# IDAP REPORT

<b>Property:</b>	35 Wakeford Road STRATHFIELD Lot: 7 DP: 15343 DA2020/249
<b>Proposal:</b>	Demolition of all existing structures & construction of a two (2) storey dwelling with basement level and front boundary fence.
<b>Applicant:</b>	Vision Group Architects
<b>Owner:</b>	Tianyu Ma
<b>Date of lodgement:</b>	15 January 2021
<b>Notification period:</b>	1 February 2021 to 15 February 2021
<b>Submissions received:</b>	One (1)
<b>Assessment officer:</b>	D Strbac
<b>Estimated cost of works:</b>	\$1,594,131.00
<b>Zoning:</b>	R2-Low Density Residential - SLEP 2012
<b>Heritage:</b>	No
<b>Flood affected:</b>	No
<b>Is a Clause 4.6 Variation Proposed:</b>	No
<b>RECOMMENDATION OF OFFICER:</b>	<b>APPROVAL</b>

Figure 4: Proposed front (south) elevation.

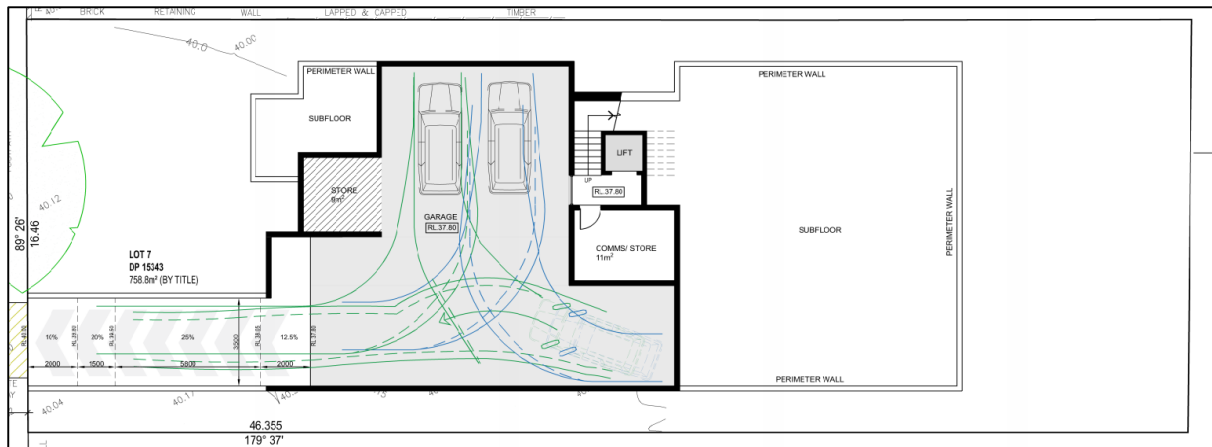
The proposed front fence design is such that a portion of the fence exceeds the minimum height requirement of 0.7m for the solid component (Figure 12). The proposed front fence design is considered to be acceptable nonetheless, as the 1.34m solid component provides a planter box for landscaping which will soften this masonry element. This component only extends for a length of 5.8m and the remaining and majority of the fence is of a picket style, therefore still allowing for passive surveillance of the street. The proposed front fence design is considered to add visual interest and is well within the overall 1.5m height requirement. The minor departure is therefore considered to be supportable and acceptable.

Figure 10: Basement floor plan with ground floor building footprint outlined in red

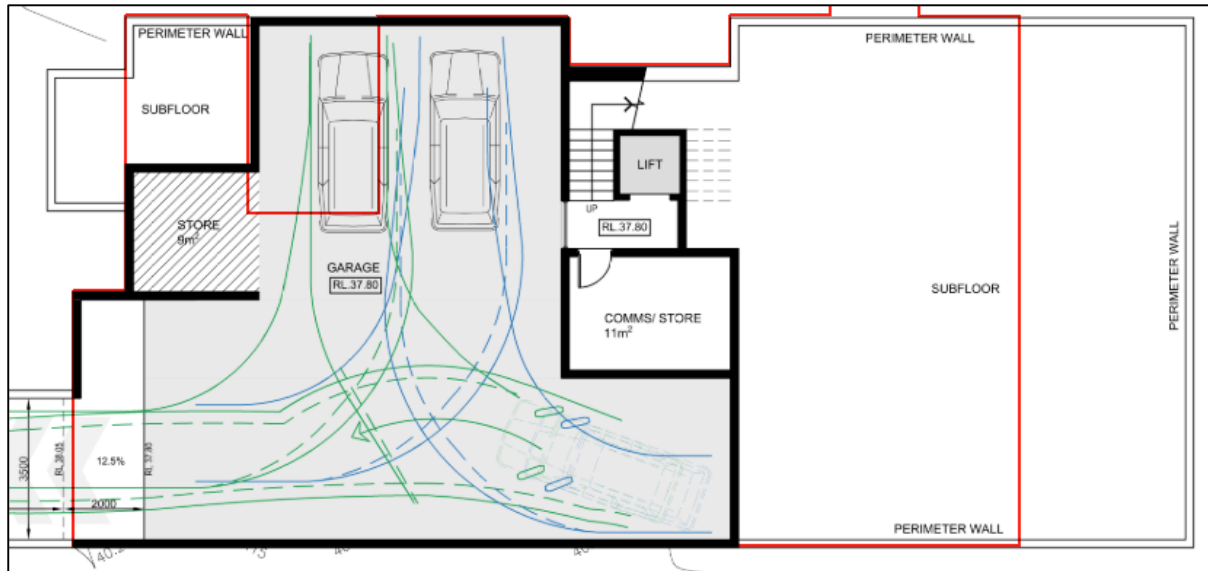
The proposal involves significant excavation works for the provision of a basement, driveway ramps and ancillary works. The proposed basement is mostly contained within the footprint of the ground floor level above. Whilst the proposed basement design exceeds the footprint of the ground floor above (Figure 10), it is noted that areas of the basement that exceed the ground floor footprint are required for the minimum two (2) car parking spaces and sufficient manoeuvring area to allow vehicles to enter and exit in a forward direction. The proposed basement is not considered to be of an excessive size and the depth of excavation has been kept to minimum requirements to comply with Council's DCP controls. The proposed works

The proposed basement exceeds the footprint of the ground floor above. However, the areas of the basement that exceed the ground floor footprint are considered necessary to allow for the minimum two (2) car parking spaces and sufficient manoeuvring area for vehicles to enter and exit the basement in a forward direction. The areas beyond the ground floor footprint are minor and will not be highly visible nor contribute to excess bulk and scale. Further, the built form is appropriately setback and balanced by the proposed landscaping treatments within the setback zones. The proposed works are unlikely to disrupt or effect existing drainage patterns or soil stability in the locality or effect the future use or development of the land. It is unlikely to effect the existing and likely amenity of adjoining properties. The basement has been kept to less than 1m above natural ground level and maintains an internal height of 2.2m. The excavation works proposed for the basement are considered to be reasonable and the non-compliance is minor and acceptable in this instance.
